Our ref: HMS Application No 1444

Notice of Exhibition of application for MOD 2, Proposed design modifications (SSD-10384 - Mod-2)

ATTACHMENT A

1.4 Juliet Balconies to Bedrooms CHANGE TO REMOVE JULIET BALCONIES TO BEDROOMS

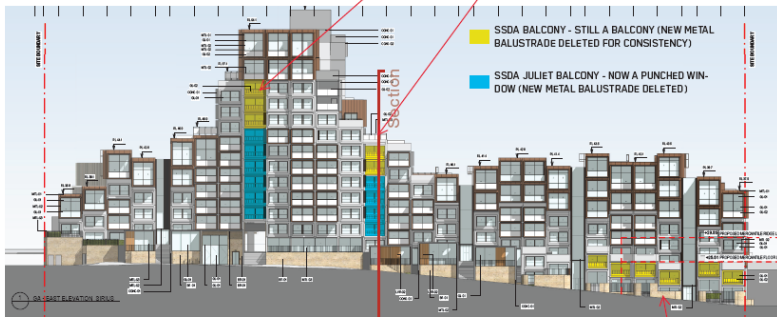
Following consultation with Heritage NSW, the applicant has agreed to retain and reuse existing metal balustrades to the six terraces as noted in the attached drawing (Attachment A). On balance, the changes to the approved balconies on upper levels to replace metal balustrade with glazed balustrade (as highlighted in yellow in Attachment A) is considered acceptable.

It is further noted the treatment of balconies (highlighted in blue) at the lower levels vary from those highlighted in yellow and feature punched windows without any balustrades. The rationale for the inconsistent treatment is not clearly explained in the submitted documentation. It is considered that a more consistent treatment across all affected balconies (as highlighted in blue and yellow) would have a better outcome. This would also align better with the intent of the approved SSD that features consistent treatment to balconies with balustrades on all these levels.

Juliette balconies in the tower to be deleted shown coloured blue. Metal balustrades to balconies shown in yellow to be glazed for consistency

INTERPRETATION OF NCC REQUIRES RESTRICTORS TO SLIDING DOORS MAX 125MM OPENING TO BEDROOMS.

THE S4.55 PROPOSAL IS TO REMOVE JULIET BALCONIES TO BEDROOMS (SLIDING WINDOWS WITH BALUSTRADE IN FRONT) AS NO LONGER FEASIBLE, AND REPLACE WITH OPERABLE GLAZING CONSISTENT WITH OTHER AREAS OF GLAZED OPENING IN THE FACADE

Location of Adjusted Glazing Lines

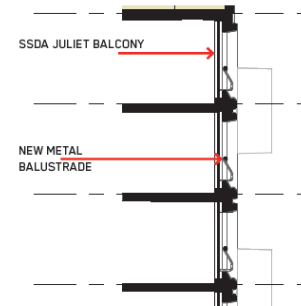
following consultation with HNSW and DIP these 6 terraces are proposed to retain the existing balustrades with a glazed balustrade behind to meet compliance.
